Subject: Proposed Davenport Recycled Water Project, Initial Study/Mitigated Negative Declaration, SCH #2015022075, Santa Cruz County

**Subject: Davenport Recycled Water Project
Coastal Commission Comments on Draft Initial Study/Proposed MND**

Re: Responses to the Davenport Recycled Water Project Coastal Commission Comments on the Draft IS/MND

Re: Responses to the Davenport Recycled Water Project MBUAPCD Comments on the Draft IS/MND

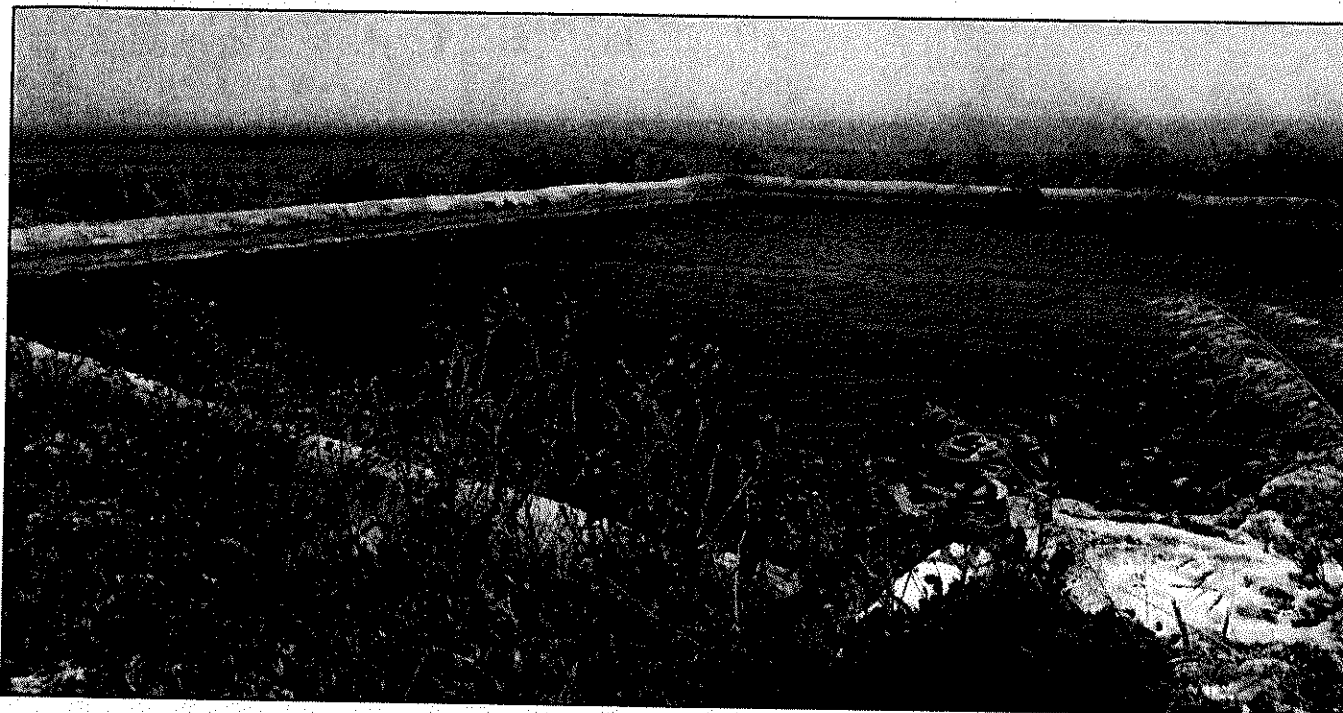
New Filling Station: Similarly, the project description (and Figure 3) identifies a new filling station on Coast Dairies Agricultural Parcel Two. Moreover, it would appear that the new filling station would require construction of a road to provide vehicular access. However the potential visual impacts of this road development are not addressed in the aesthetic and visual resources section of the MND.

New Distribution Pipes: The project description identifies development activities related to new distribution pipes. Based on Figure 2, piping will also be required to connect the existing wastewater facility plant to the new storage pond. The visual resource section of the MND notes that "all distribution lines would be buried." However, the project description notes that the pipe installed on the west side of Highway 1 "would have laterals rising above grade and topping over

The preliminary location of the truck fill station was located in front of the proposed storage pond. However, after further design, the location would be located at the existing Davenport Wastewater Treatment Plant site. The truck fill station would be located on existing pavement behind the existing screening of trees that surround the existing plant site.

Fill pipe located at agricultural pond located adjacent to Highway 1 on APN 058-021-03.
